ADDENDUM NO. 4

PROJECT: Garvin Building Hazardous Material Abatement & Renovation Floors 3, 4, & 5

ADDENDUM #01

Building 75 – Garvin Building Hazardous Material Abatement & Renovation Floors 3, 4, & 5
425 Robinson Street
Binghamton, NY 14224

Drawing Title
**PARTIAL CEILING
REMOVAL PLAN -
3RD FLOOR - WING E**

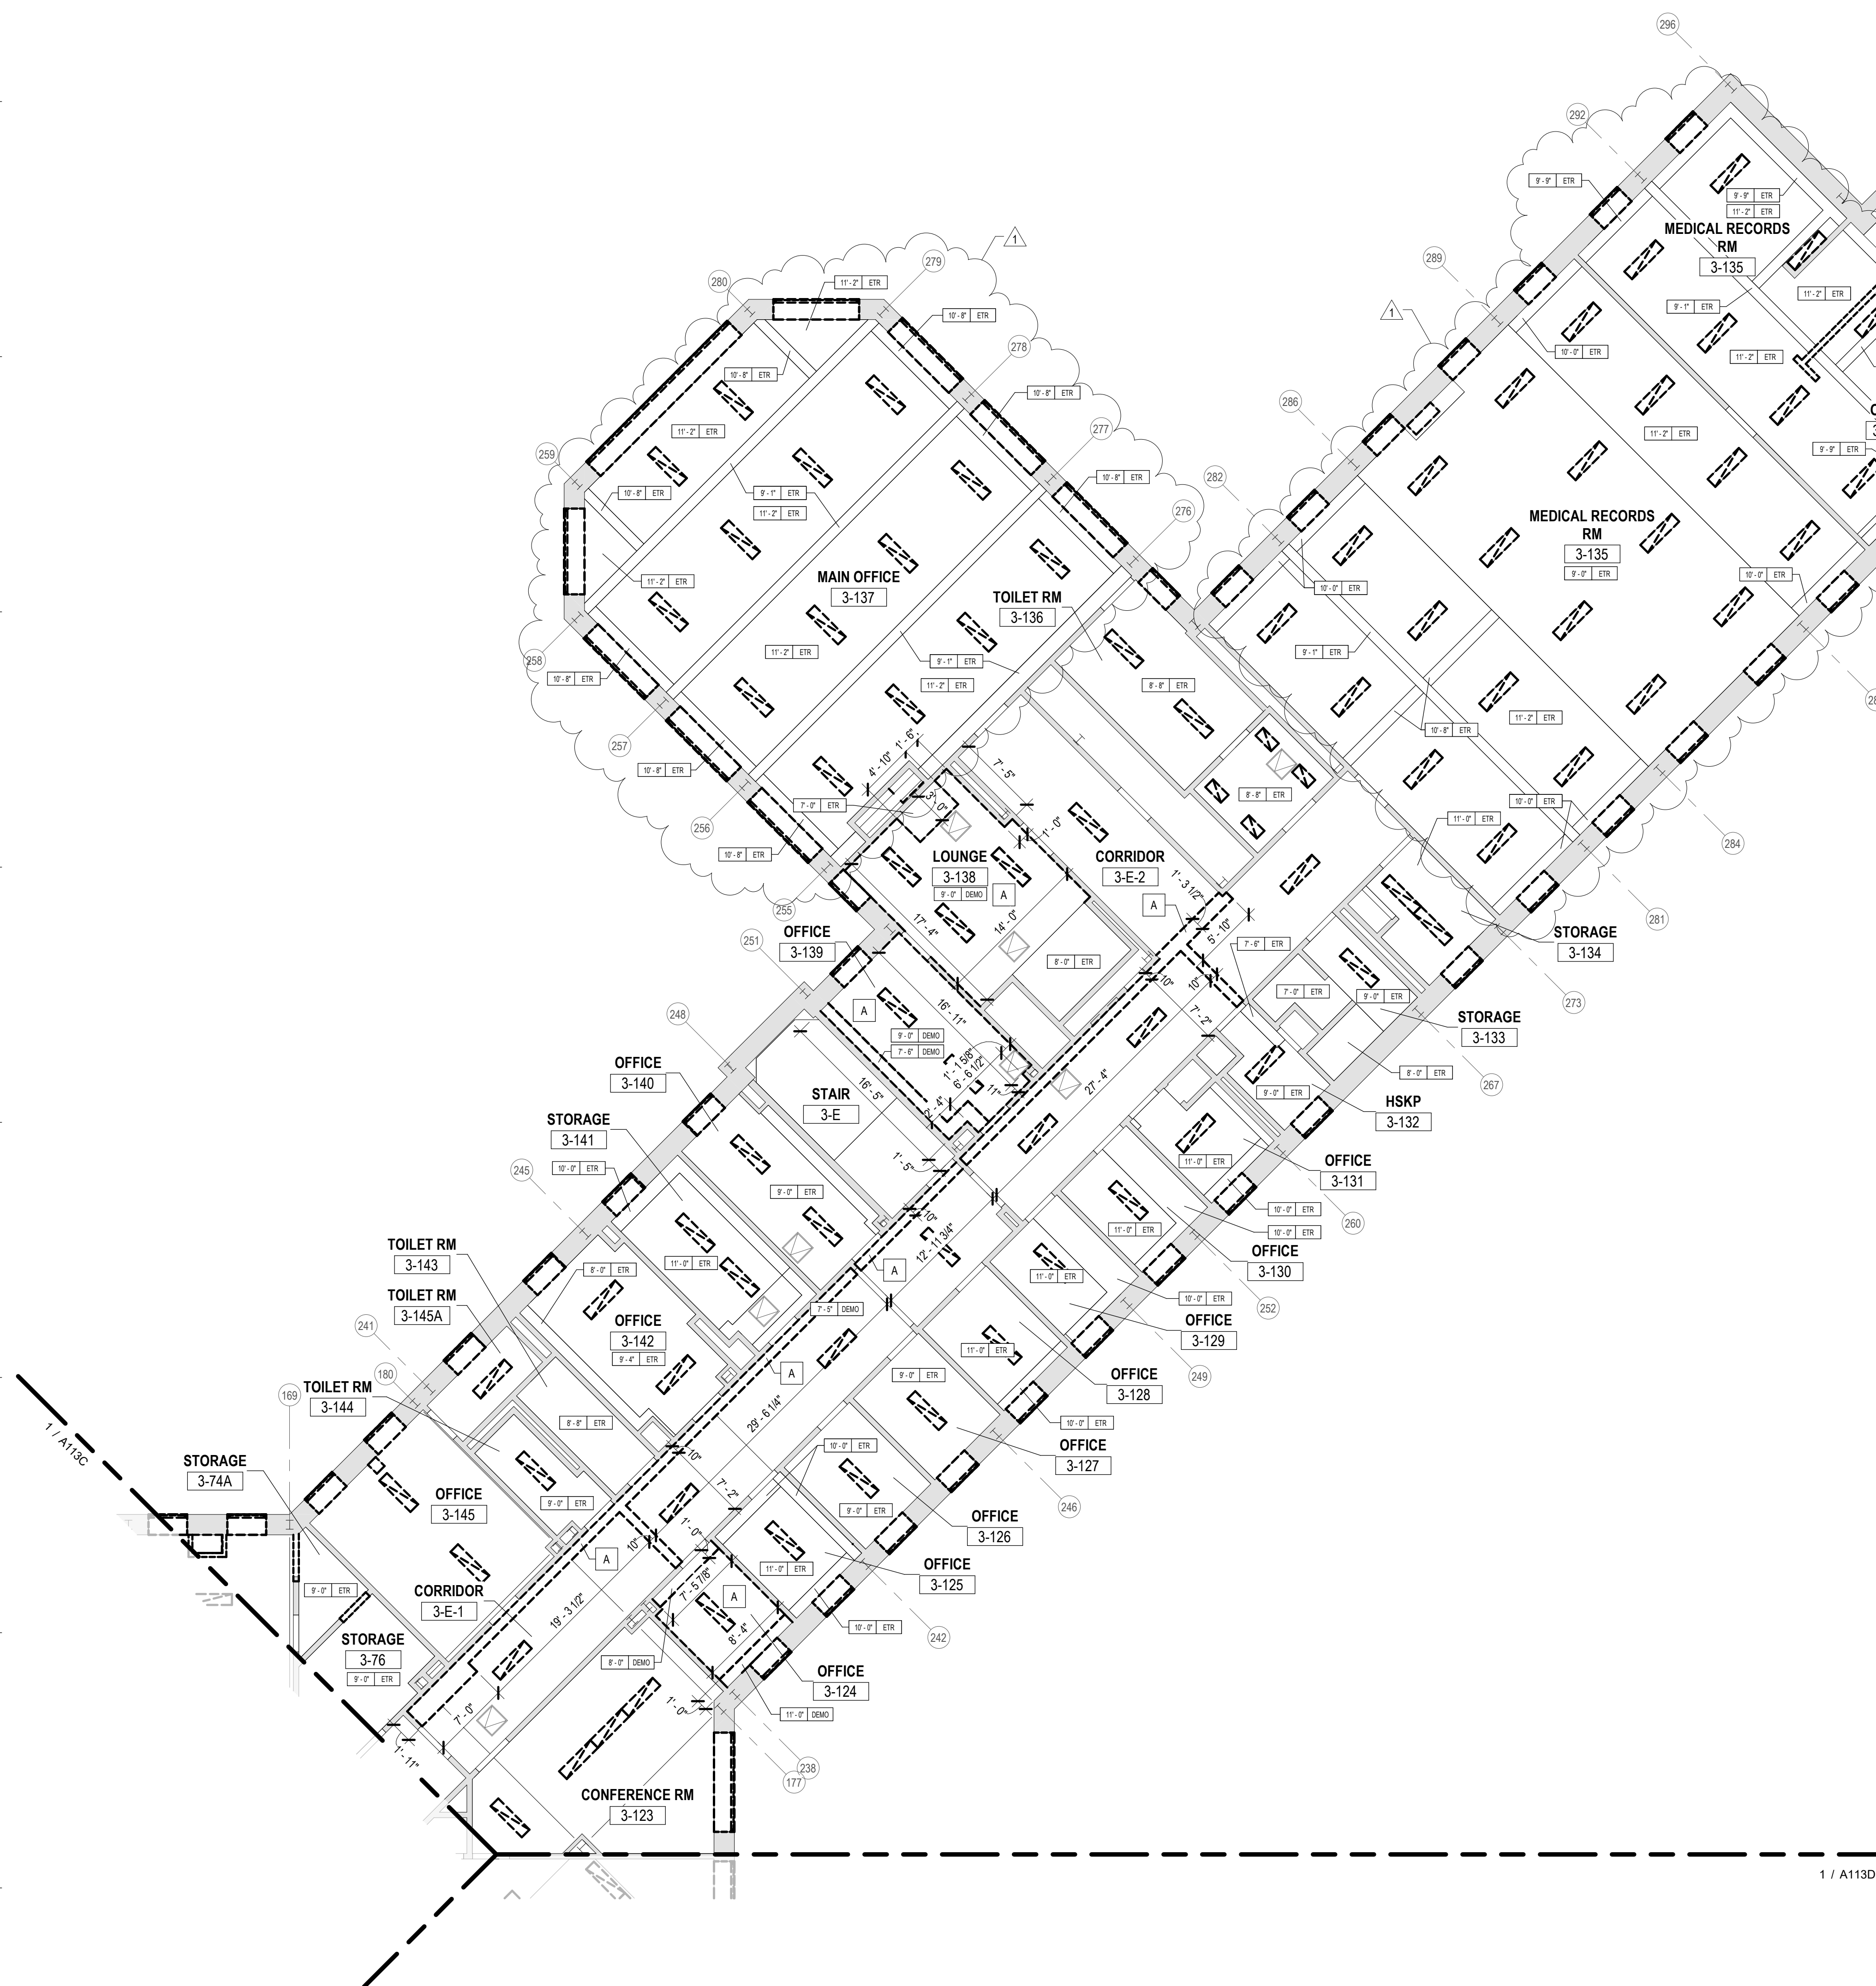
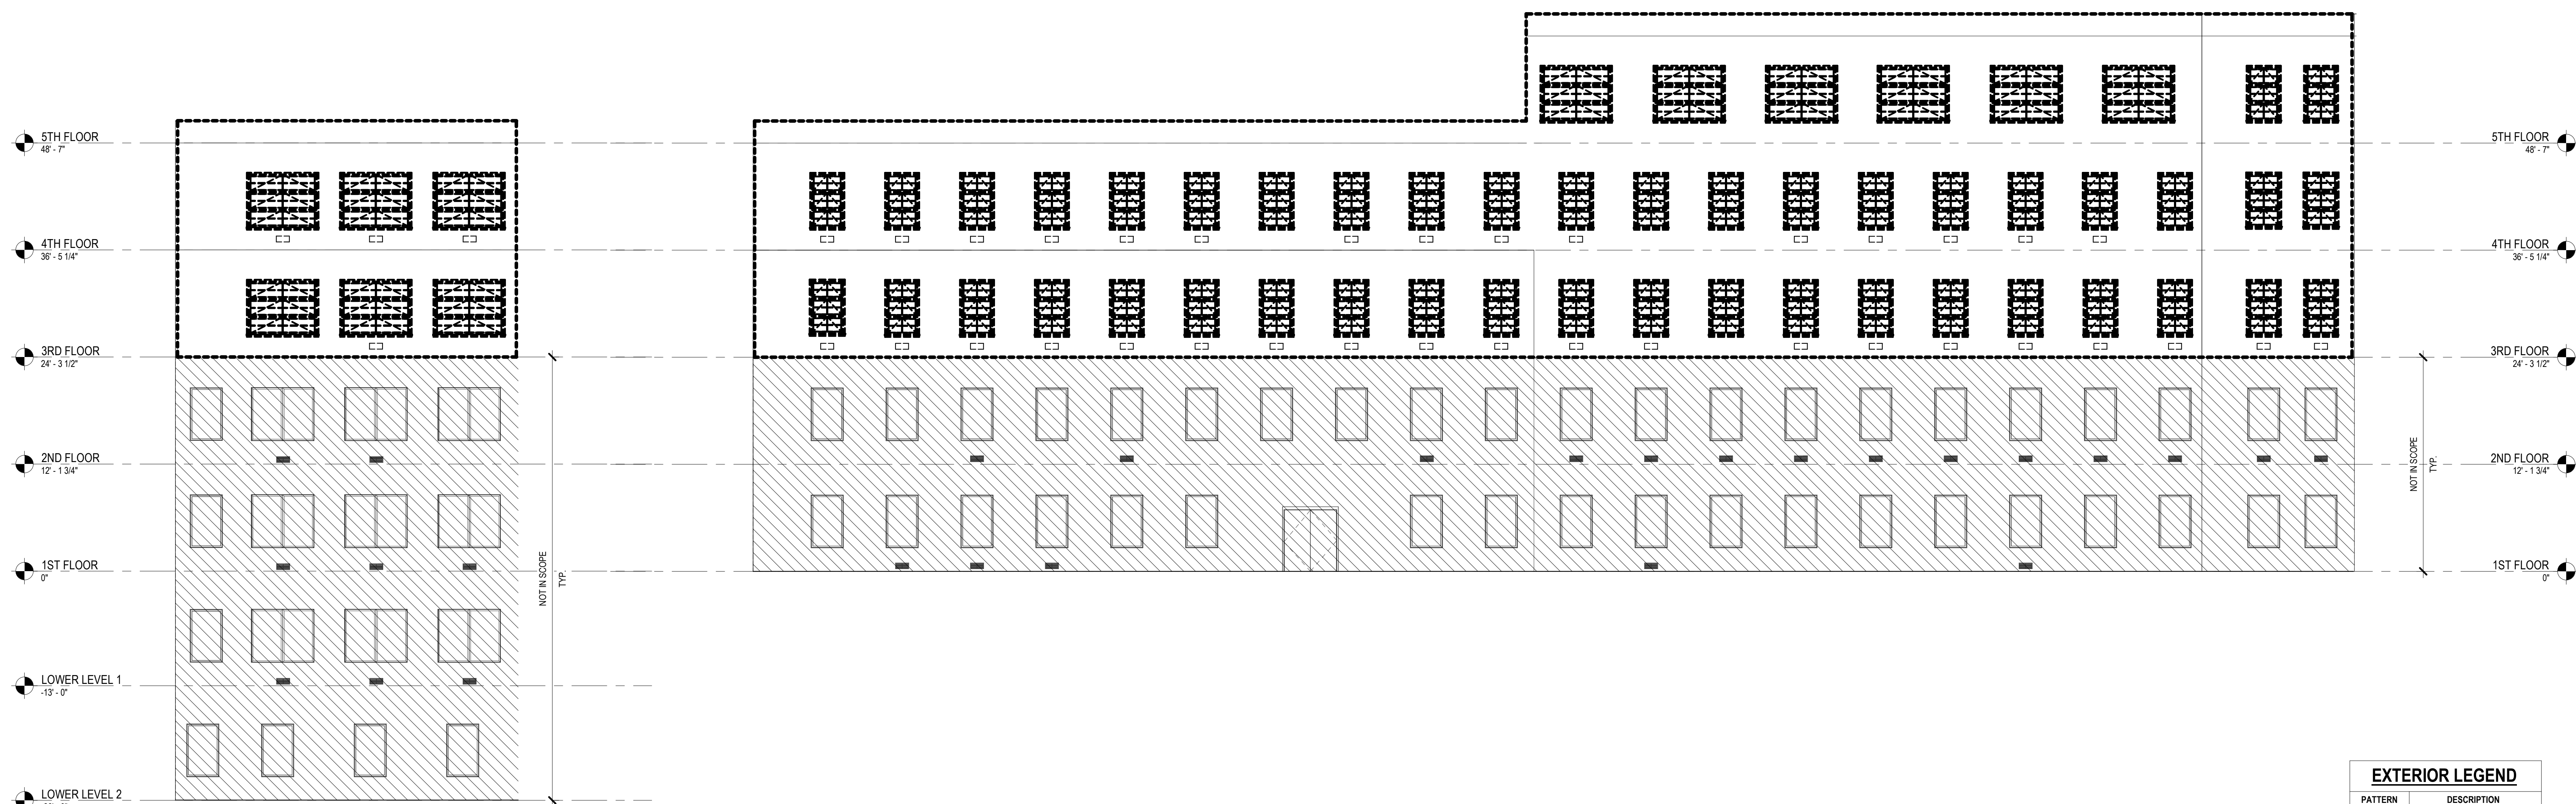
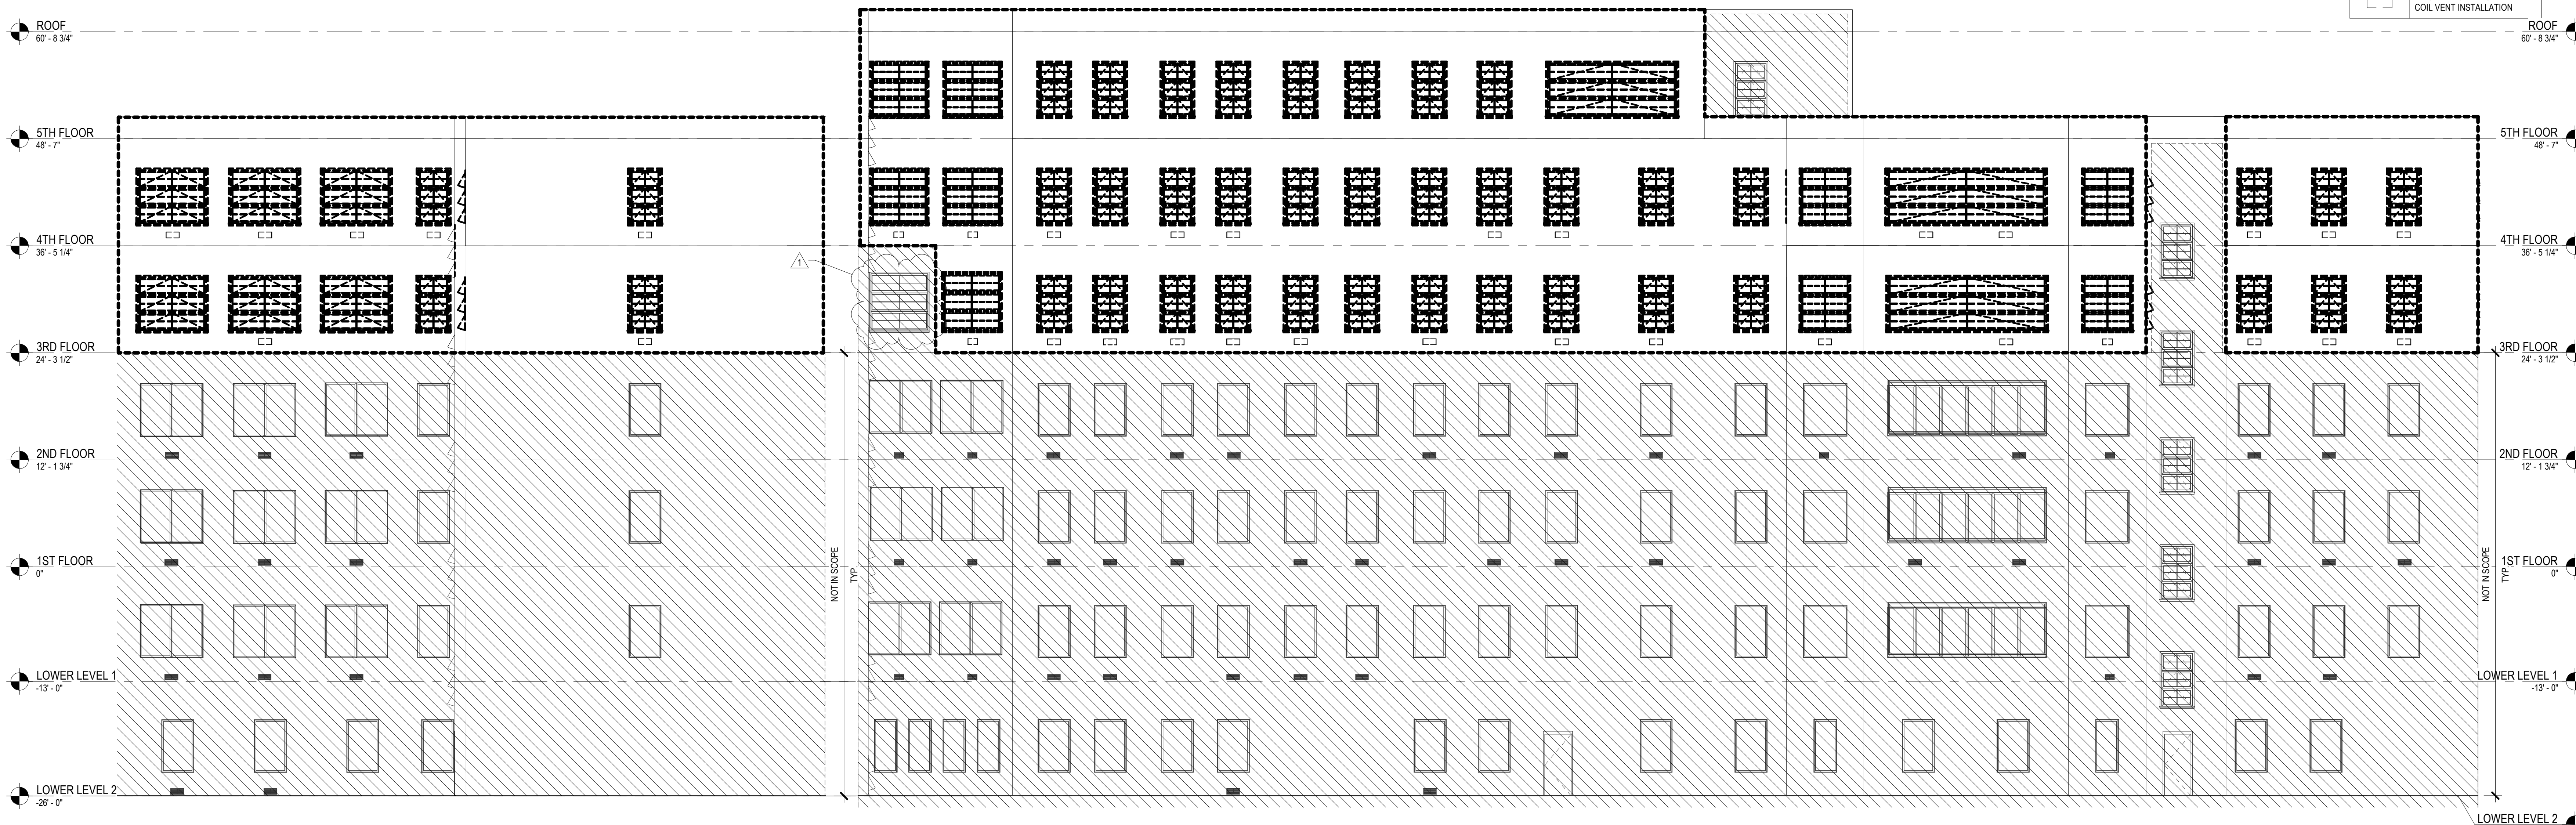
- e) AD113E – Partial Ceiling Removal Plan – 3rd Floor – Wing E: **REVISE** ceiling demolition scope in Office 3-135A and ceiling tags in the following rooms: Medical Records Rm 3-135 and Main Office 3-137.
